Change Order

PROJECT: *(Name and address)*
Webb County JC-Building Envelope and
Site Rehabilitation Project
1110 Victoria St., Laredo, TX 78040

CHANGE ORDER INFORMATION:
Change Order Number: 002

Construction Change Directive

SHEET
A3.02
OF

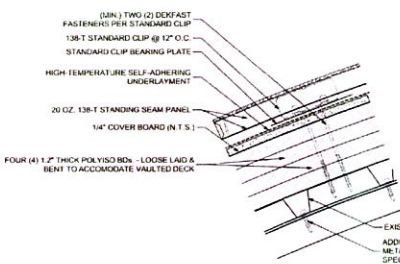
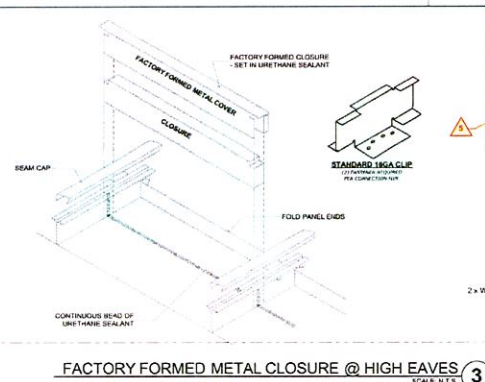
As identified in attached Drawings A3.02 and A7.07-A, reissued for CCD #02 on August 18, 2025, the Contractor shall evaluate all options presented and after analyzing the options for cost and schedule, shall provide the Architect and Owner a summary of the cost and time estimates for each option, from which the Owner and Architect will select and approve for execution. All parties understand that because the scope of this CCD involves unknown conditions and potentially volatile pricing caused by the current state of the markets, it will be impossible to identify the total cost for the work of any of these options identified in this CCD until it is completed. As time is of the essence, the Contractor shall commence work as soon as approval of the Option / Options by the Owner.

ALTERNATE No. 1 - SECTION DETAIL - PARAPET @ FRAMED COPPER CLADDED CORNICE (Level 6)

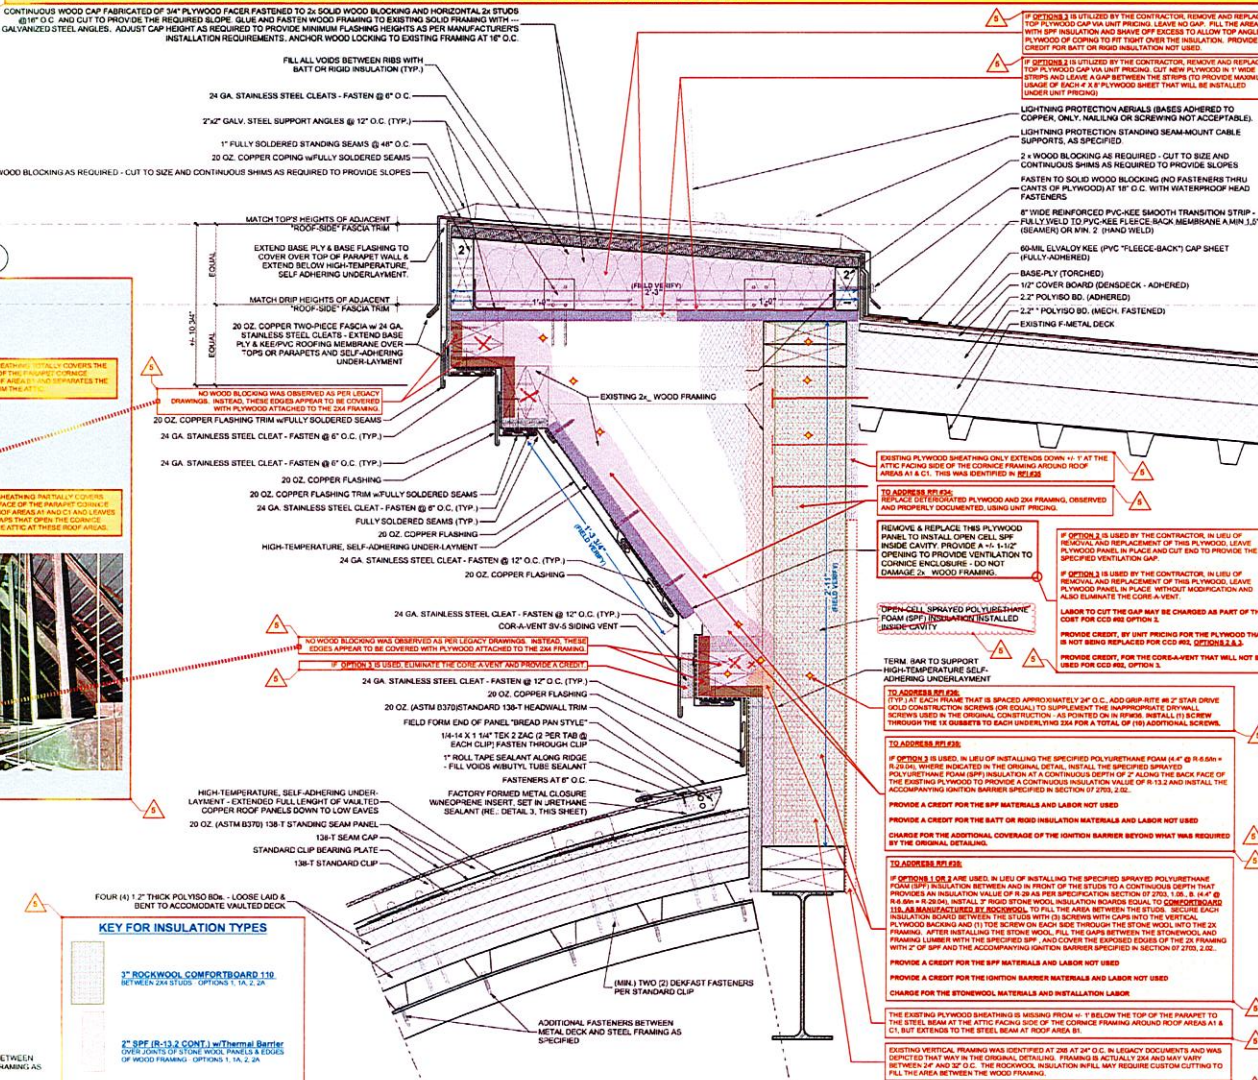
As per RFI #34, RFI#35 and RFI#36, the Contractor has identified possible deteriorated plywood and 2x wood framing, missing vertical plywood sheathing on the attic side of the cornice and the use of improper screws to secure the framing. Drawing sheet A7.07-A has been modified to Address RFI #34, RFI#35 and RFI#36 and to define the scope of work for Construction Change Directive #02 (CCD #02).

AT THE CONTRACTOR'S OPTION, IN ORDER TO INSTALL THE NEW INSULATION INSIDE THE CORNICE CONTRACTION, AND TO REPLACE ANY DETERIORATED PLYWOOD AND WOOD FRAMING MEMBERS AND TO ADD FASTENERS TO THE FRAMING TO SUPPLEMENT THE EXISTING DEFICIENT FASTENERS THE CONTRACTOR MAY EITHER:

OPTION 1 - WORK FROM MOBILE LIFTS AS ORIGINALLY PROPOSED TO REMOVE AND REPLACE THE PLYWOOD ON THE ANGLED VERTICAL FACE OF THE CORNICE AS CALLED OUT IN THE CURRENT CODE TO GAIN ACCESS FOR THE NECESSARY OBSERVATIONS AND REPAIRS IDENTIFIED IN CDD #32. UTILIZING A COMBINATION OF ROCKWOOL AND THE SFP INSULATION AND IGNITION BARRIER CURRENTLY IN THE CONTRACT, BEFORE INSTALLING THE NEW PARAPET CAP EXTENSION FILLED WITH BATT OR RIGID INSULATION. (OPTION 1A, ONLY AT ROOF AREA B1, SHOULD USE THE CURRENTLY SPECIFIED SFP INSULATION AND THERMAL BARRIER.)

OPTION 2 - WORK FROM ROOF LEVEL WITHOUT MOBILE LIFTS TO REMOVE AND REPLACE THE EXISTING PLYWOOD CAP AT THE CORNICE AS DETAILED BY CDD #32 VIA UNIT PRICING TO GAIN ACCESS FOR THE NECESSARY OBSERVATIONS AND REPAIRS IDENTIFIED IN CDD #32. UTILIZING A COMBINATION OF ROCKWOOL AND THE SFP INSULATION AND IGNITION BARRIER CURRENTLY IN THE CONTRACT, BEFORE INSTALLING THE NEW PARAPET CAP EXTENSION FILLED WITH BATT OR RIGID INSULATION. THIS OPTION WILL PROVIDE THE OWNER A CREDIT VIA UNIT PRICING FOR THE VERTICAL PLYWOOD THAT WILL NOT BE REPLACED AS A CONSEQUENCE, AND SHOULD PROVIDE THE CONTRACTOR THE OPPORTUNITY TO REDUCE THEIR LABOR AND ACCESS COSTS, WHICH DO NOT NEED TO BE CREDITED TO THE OWNER. (OPTION 2A, ONLY AT ROOF AREA B1, SHOULD USE THE CURRENTLY SPECIFIED SFP INSULATION AND THERMAL BARRIER.)

OPTION 3 - WORK FROM ROOF LEVEL WITHOUT MOBILE LIFTS TO REMOVE AND REPLACE THE EXISTING PLYWOOD CAP AT THE CORNICE AS DETAILED BY CDD #32 VIA UNIT PRICING TO GAIN ACCESS FOR THE NECESSARY OBSERVATIONS AND REPAIRS IDENTIFIED IN CDD #32. UTILIZING THE SFP INSULATION AND IGNITION BARRIER CURRENTLY IN THE CONTRACT, BEFORE INSTALLING THE NEW PARAPET CAP EXTENSION. THIS OPTION WILL PROVIDE THE OWNER A CREDIT FOR THE VERTICAL PLYWOOD AND CORNICE VENT THAT WILL NOT BE REPLACED AS A CONSEQUENCE, AND SHOULD PROVIDE THE CONTRACTOR THE OPPORTUNITY TO REDUCE THEIR LABOR AND ACCESS COSTS, WHICH DO NOT NEED TO BE CREDITED TO THE OWNER. (OPTION 3 IS NOT VAILABLE FOR ROOF AREA B1, BECAUSE IT WOULD CREATE A CORNICE VENT THAT IS NOT VENTILATED.)

1. For the replacement of existing plywood (addition), and the elimination of contracted scope that involves the replacement of existing plywood (deduction), for all options, use the unit pricing schedule in the contract.
2. For the replacement of existing deteriorated plywood and lumber, for all options, that are not otherwise scheduled to be replaced that are related to RFI #34, that has been properly catalogued to identify the deterioration, type, size, length and/or area, use the unit pricing schedule in the contract.

3. For the addition of screws to supplement the currently deficient screw installation identified in RFI # 36, for all options, provide the cost to procure and install these screws plus any allowances for overhead and profit that may be applicable in accordance with the construction contract.

4. For the addition of rigid stone wool insulation to accommodate the missing plywood identified in RFI # 35, for Options 1, 1A, 2, and 2A, provide the cost to procure and install these insulation boards plus any allowances for overhead and profit that may be applicable in accordance with the construction contract.

5. For the addition of the scope for the ignition barrier identified in Specification Section 07 2703, for Option 3, provide the cost to procure and install the additional materials plus any allowances for overhead and profit that may be applicable in accordance with the construction contract.

6. For the reduction of scope for the Sprayed Polyurethane foam insulation identified in Specification Section 07 2703, for Options 1, 1A, 2, 2A and 3, credit the Owner for all materials not used, plus the labor not used commensurate to the reduction in materials, plus the commensurate reduction in overhead and profit related to the reduction of the installed scope.

7. For the reduction of scope for the ignition barrier identified in Specification Section 07 2703, for Options 1, 1A, 2, and 2A, credit the Owner for all materials not used, plus the labor not used, commensurate to the reduction in materials, plus the commensurate reduction in overhead and profit related to the reduction of the installed scope.

8. For the deletion of the Core-A-Vent SV-5 Siding vent materials for Option 3, credit the Owner for all materials not used, plus the labor not used, commensurate to the reduction in materials, plus the commensurate reduction in overhead and profit related to the reduction of the installed scope.

9. For the deletion of the batt or rigid insulation materials at the coping framing for Option 3, credit the Owner for all materials not used, plus the labor not used, commensurate to the reduction in materials, plus the commensurate reduction in overhead and profit related to the reduction of the installed scope.
